Document ID: IK1900268

Title: Side Mounted Cab Extender Fins that provide more flexibility during trailer contact

Applies To: International LT & LoneStar Trucks with the cab extenders that have the stiff black tail fins.

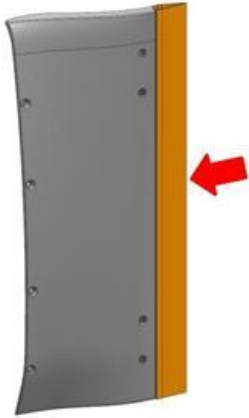
This document will guide the user through when and how to replace the 5" black plastic stiff tail fin on the cab extenders with an 8" P-shaped flexible tail fin. Each tail fin style fits and mounts to the same surfaces of the cab extender panel.

NOTE: There are a couple of cab extender configurations where the 5" tail fin should NOT be replaced with the 8" P-shaped tail fin due to durability concerns of the cab extender structure. So follow the guidelines in this article when changing over from the 5" stiff tail fin to the 8" flexible tail fin.

8" P-Shape Tail Fin	Part Number	Quantity Required	Notes
599.5mm Long (Upper)	4125217C3	1 per side	For older Hi-Rise w/18" Cab Extenders
1126.5mm Long (Lower)	4226381C2	1 per side	For newer Hi-Rise & all Sky-Rise w/18" Cab Extenders
1564.9mm Long (Upper)	4226380C1	1 per side	For newer Hi-Rise & all Sky-Rise w/18" Cab Extenders
2094.5mm Long (Lower)	4226382C1	1 per side	For Hi-Rise without a Roof Deflector
2094.5mm Long (Lower)	4124241C3	1 per side	For older Hi-Rise with 18" Cab Extenders

Day Cab - Cab Extender Options

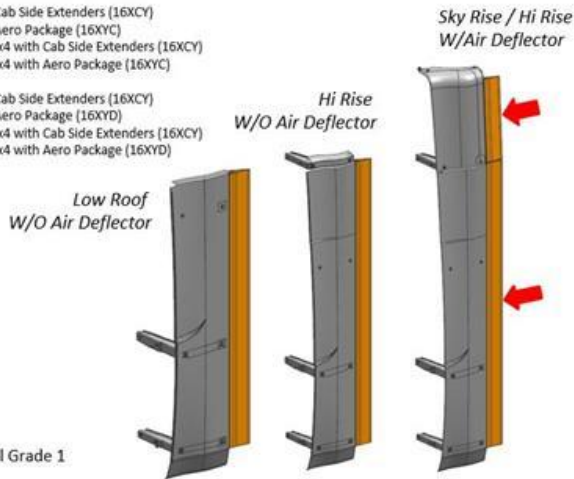
Day Cab - Cab Extender Options Currently Offered

20" Extenders + 5" Extrusions

Sleeper Cabs: Cab Extender Options

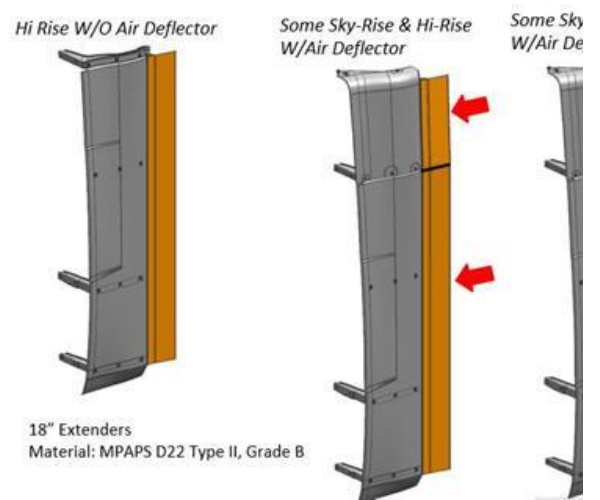
18" Extenders + 8" Extrusions (launched in June 2019)
